West End (Landmark)

Blocks E&G Amendment – DSUP#2023-10008

Comprehensive Sign Plan – SUP#2023-00011

Open Spaces – DSUP#2023-10004

Proposed Changes to Block E Layout

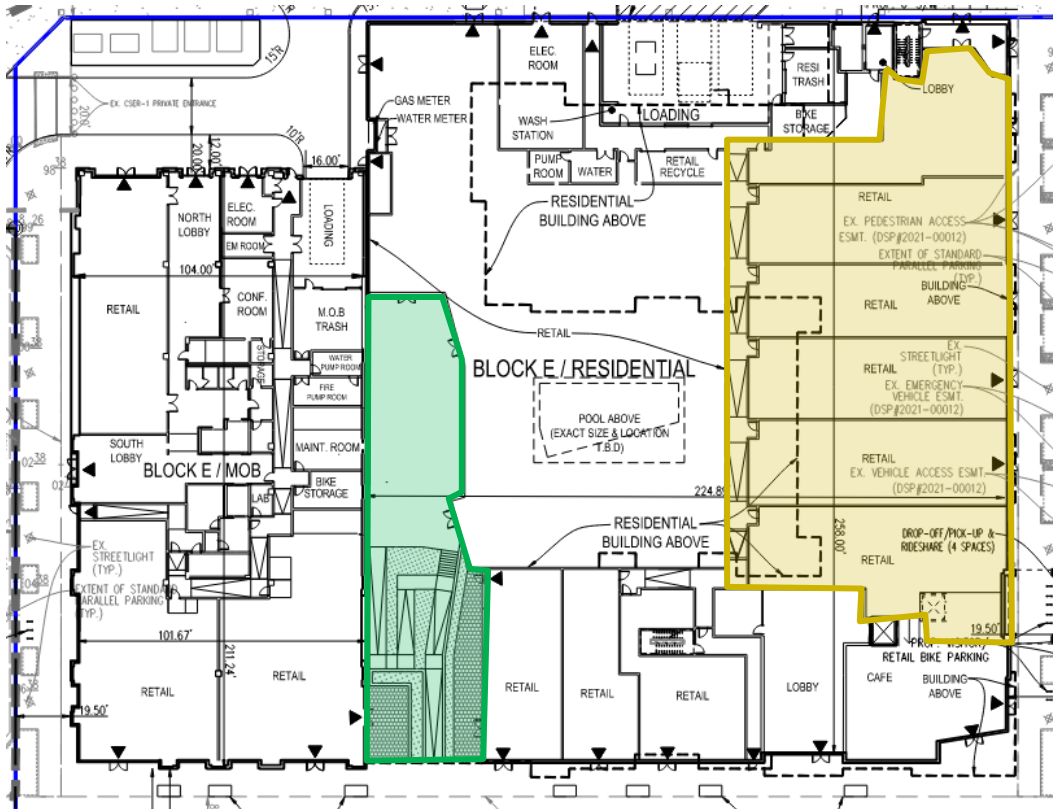
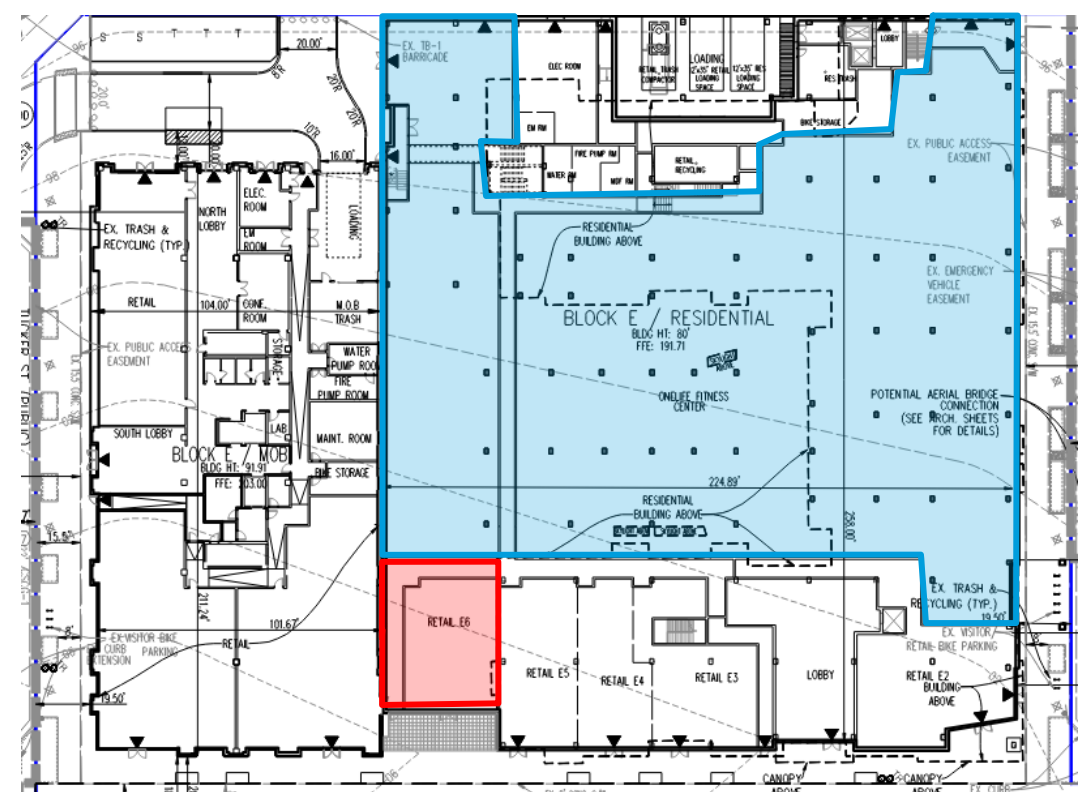
DSUP#2022-10017 **Approved Plan**

DSUP#2023-10008 **Proposed Layout**

- At-grade Courtyard
- Individual retail bays

- Enlarged retail bay with mezzanine (E7)
- New retail bay (E6)

Garage Banners Not Supported

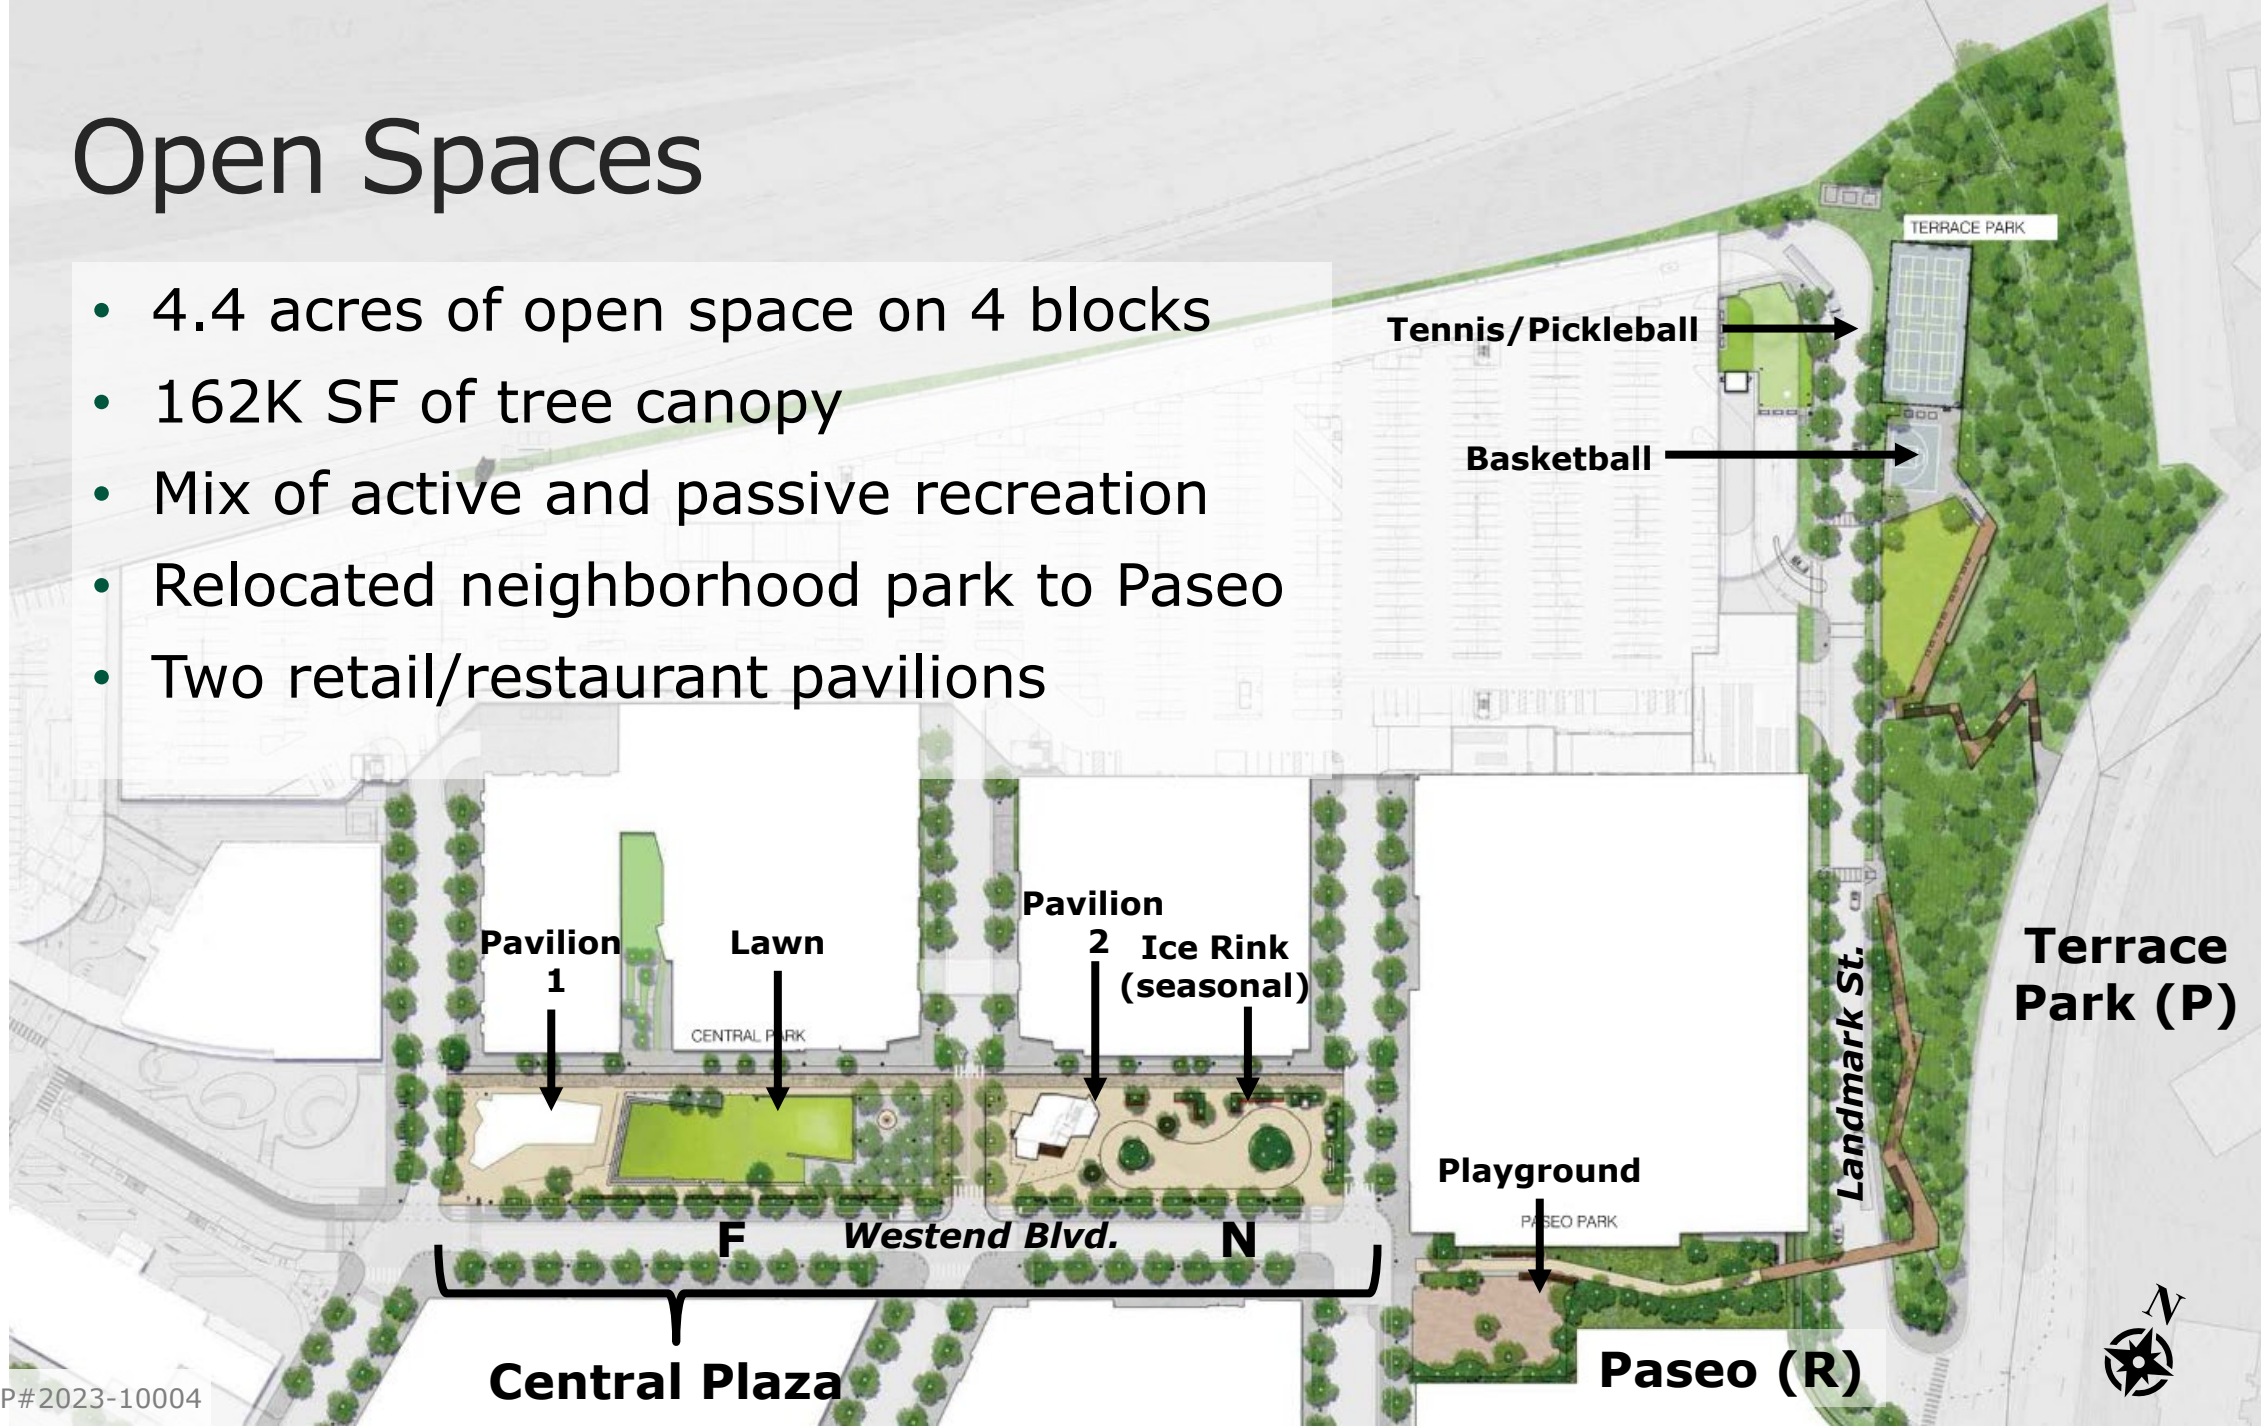
Photo from applicant of a Bethesda garage

- Proposed:
 - 12 signs (max.)
 - 100 SF (max.)
- Materials:
 - Channel letters or logos
 - Static banner elements
- Zoning Ordinance requires signs to be high aesthetic quality
- Staff supports channel letters or logos but not banners due to maintenance concerns

- **Blocks E&G Amendment**, DSUP#2023-10008
 - Staff recommend **approving this option** for flexibility in developing Block E subject to conditions in staff report
- **Comprehensive Sign Plan**, SUP#2023-00011
 - Staff recommend **approving** subject to revisions (incl. removing garage banners)
- **Open Spaces**, DSUP#2023-10004
 - Staff recommend **approving** subject to conditions in staff report
